Addendum - One

**Milwaukee County Parks Department
MARTIN LUTHER KING JR. – COMMUNITY CENTER
CONTRACT “A” - Roof Replacement
CONTRACT “B” – Waterproofing Membrane Repair
CONTRACT “C” – Combined Bid
Site Number: 773
Building Number: 2110
1531 West Vliet Street
Milwaukee, Wisconsin 53205-2117**

P172-10457

April 23, 2014

REVISIONS:
 1. 11/11/2014
 APPROVAL ONE:
 REVISED AIR COOLED
 CONDENSER UNIT
 SUPPORT FRAMING
 DATE: 06-25-2014
 PROJECT: P172-10457
 SHEET NO: 773
 BUILDING NO:
 BEST NO:
 ADD-1.1

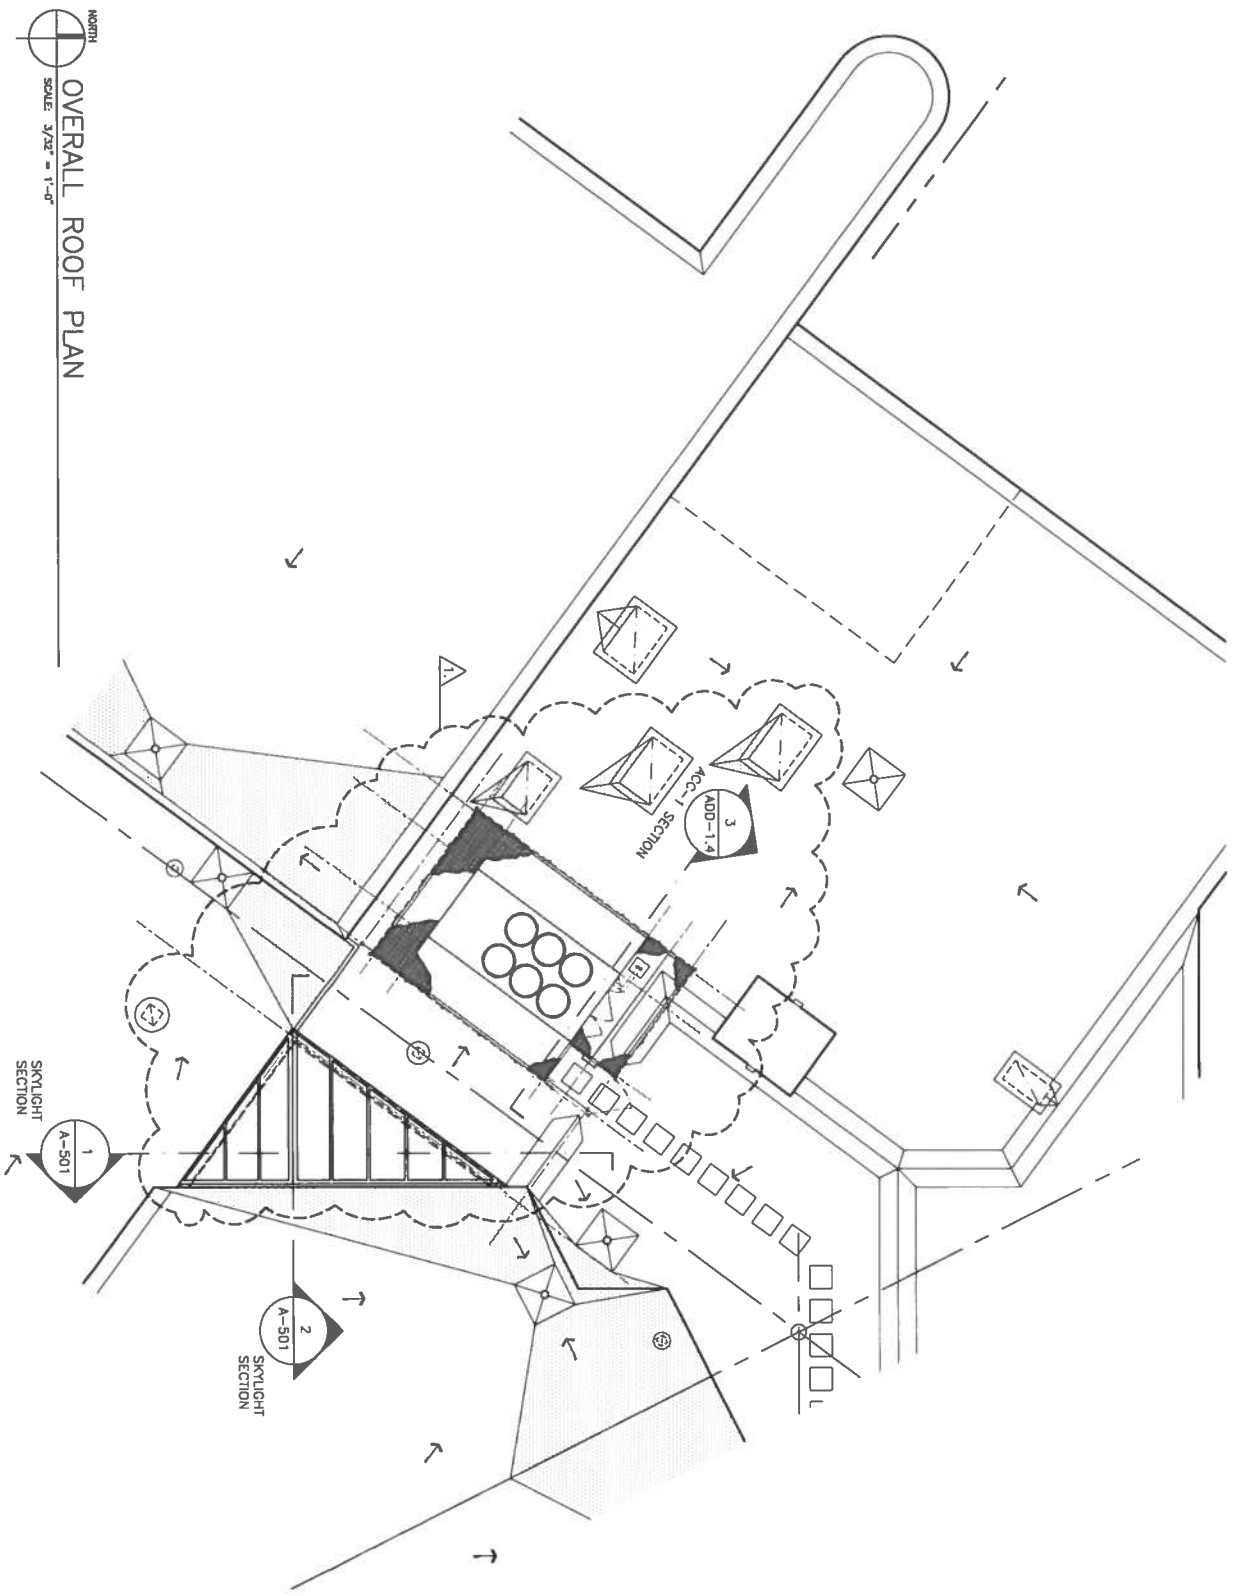
- A-201 Revised air-cooled condenser unit support framing and enclosure fence.
1. See attached drawing ADD-1.1 for partial Roof Demolition Plan: Area-A for revision.

ADD-1.2

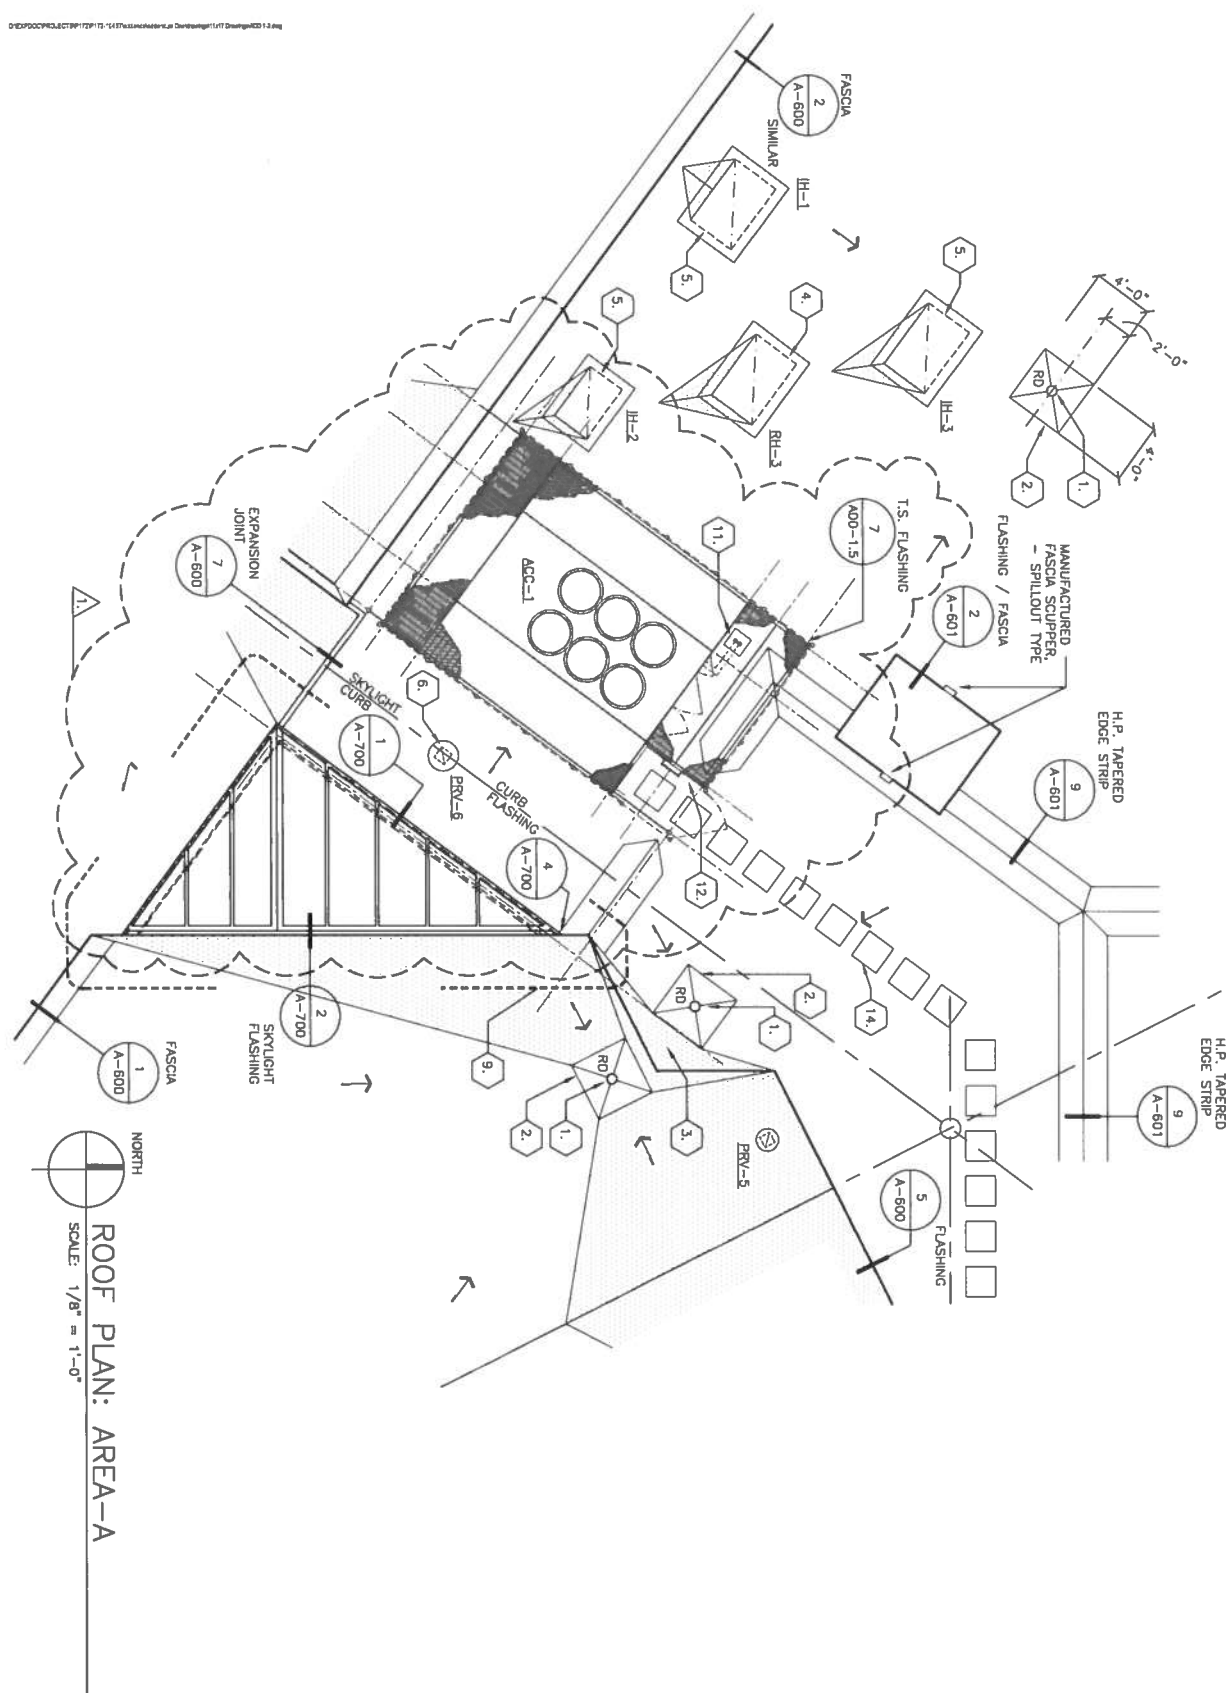
- A-400 Revised air-cooled condenser unit support framing and enclosure fence.
1. See attached drawing ADD-1.2 for partial Overall Roof Plan for air-cooled condenser unit support framing and enclosure fence revision.

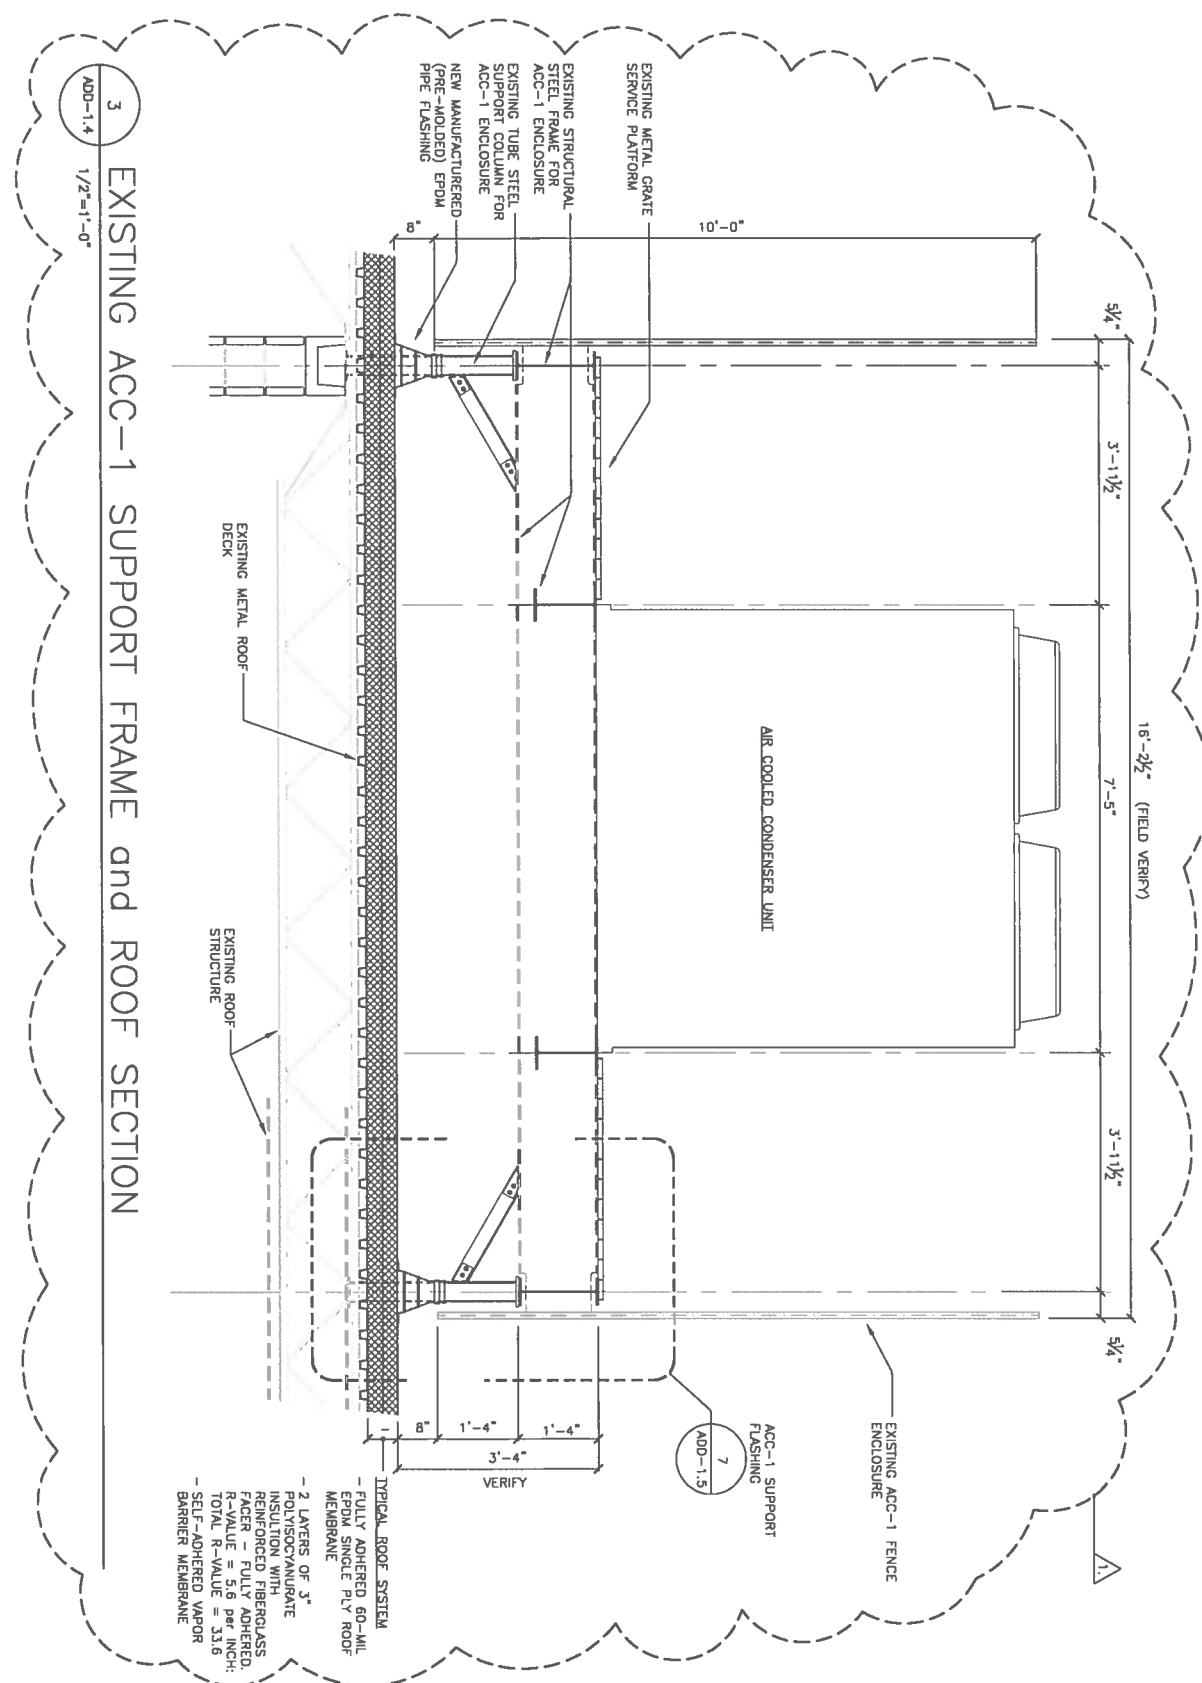
- A-501 Revised air-cooled condenser unit support framing and enclosure fence.
1. See attached drawing ADD-1.4 for Existing ACC-1 Support Frame and Roof Section.

ADD-1.5

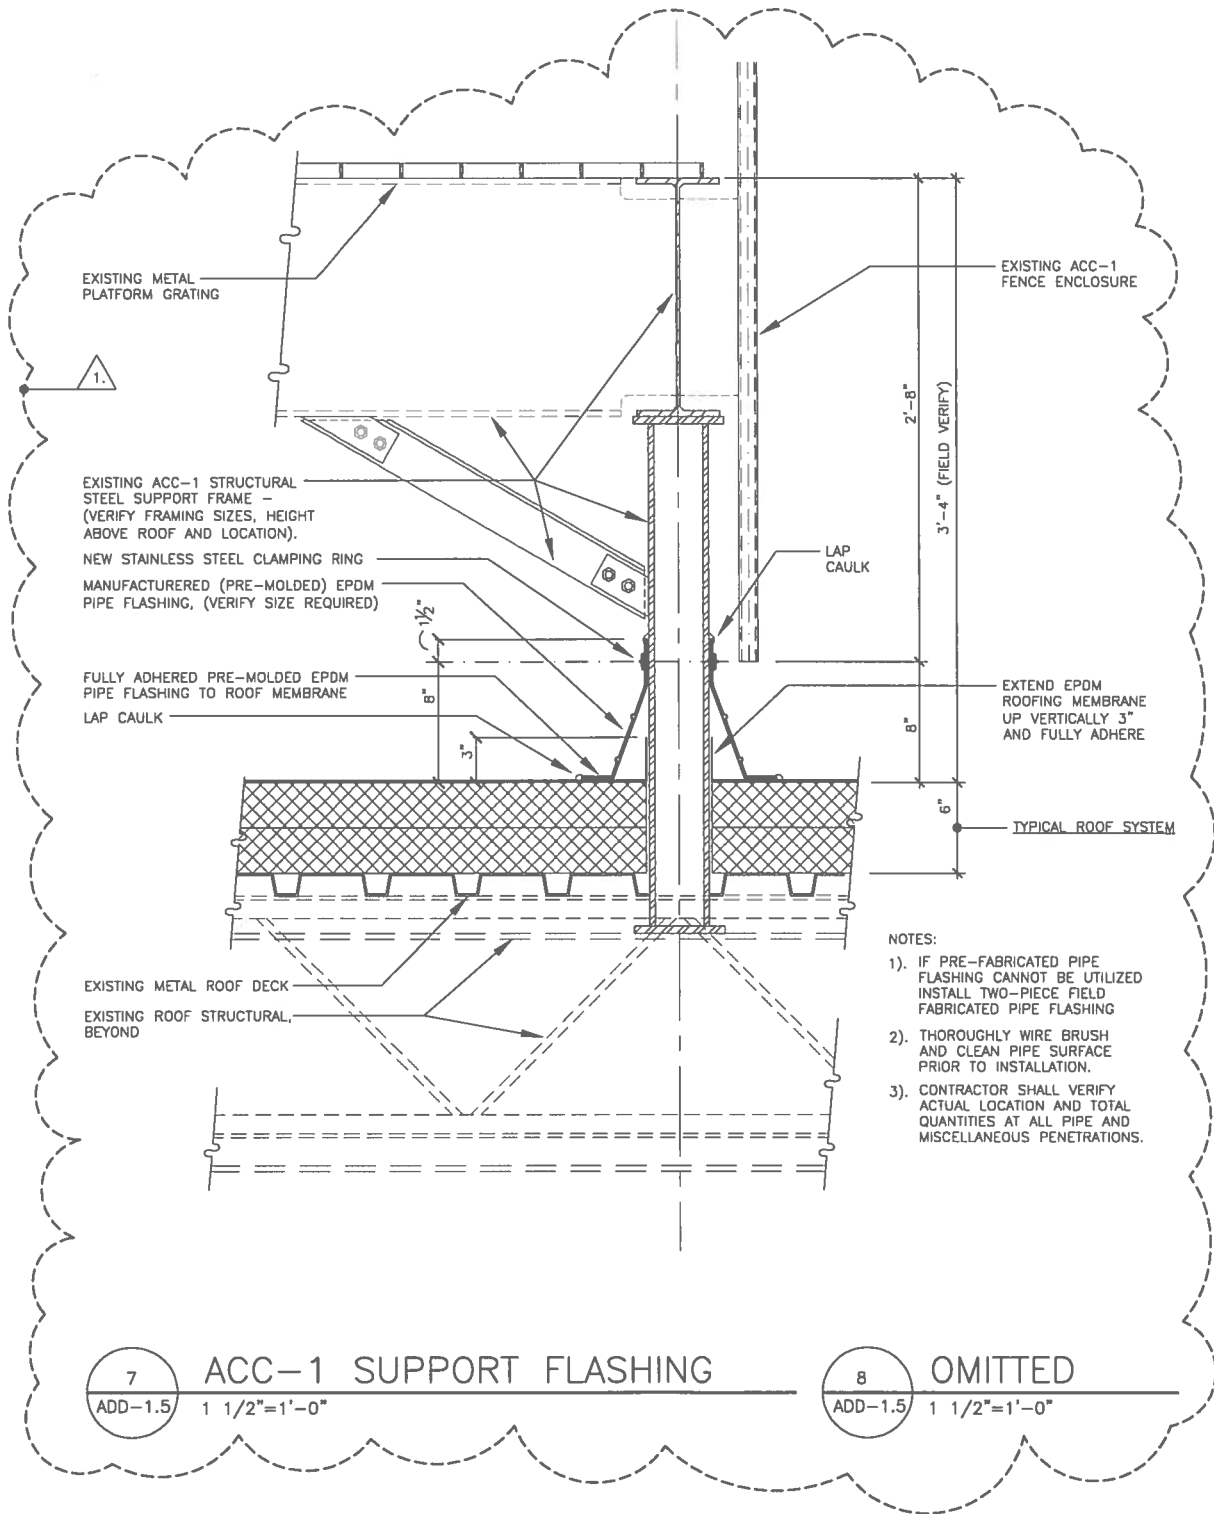
- A-601 Revised air-cooled condenser unit support framing and enclosure fence.
1. See attached drawing ADD-1.5 for ACC-1 Support Flashing Detail 7 / A-601, revised.
